SUBJECT: Removal Action Design Plan (RADP) with Effectiveness Monitoring Plan (EMP) for the P-Area Groundwater (PAGW) Operable Unit (OU) (SRNS-RP-2019-00105, Revision 1, July 2019) (Redline Pages and Clean Copy) and Savannah River Site's Responses to the Regulatory Comments on the Revision 0 Document, SEMS Number: 81

Removal Action Design Plan (RADP) with Effectiveness Monitoring Plan (EMP) for the P-Area Groundwater (PAGW) Operable Unit (OU)

SRNS-RP-2019-00105

Comments Received May 31, 2019

Figure 9. Design Data Acquisition Plan Locations

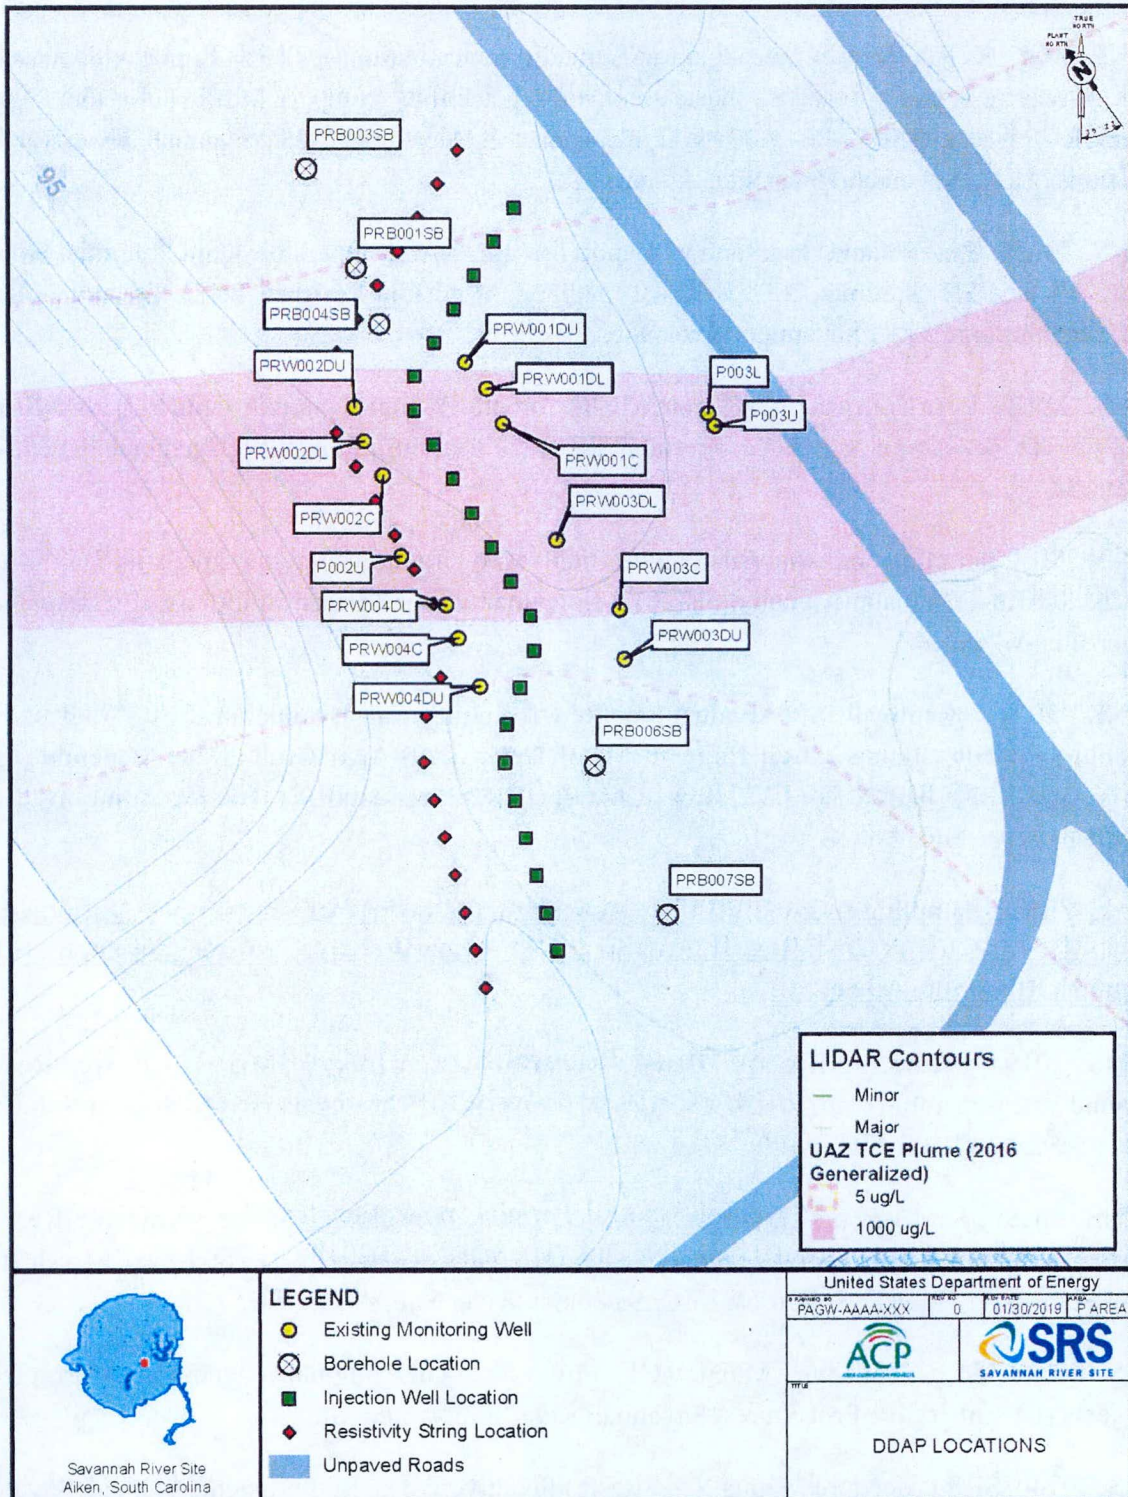
4. **Figure 10, TCE Plume Cross-Section Perpendicular to Groundwater Flow Direction and Figure 11, TCE Plume Cross-Section with ZVI-PRB Injection Wells, Pages 35 and 37 of 52:** The path of the bisects/trend-lines used for the cross-sections presented in Figures 10 and 11 is not shown on Figure 9, Design Data Acquisition Plan Locations. Revise Figure 9 to include the bisects/trend-lines used for the cross-sections presented in Figures 10 and 11.

The UAZ TCE plume delineation was added to Figure 9 (attached) as suggested.
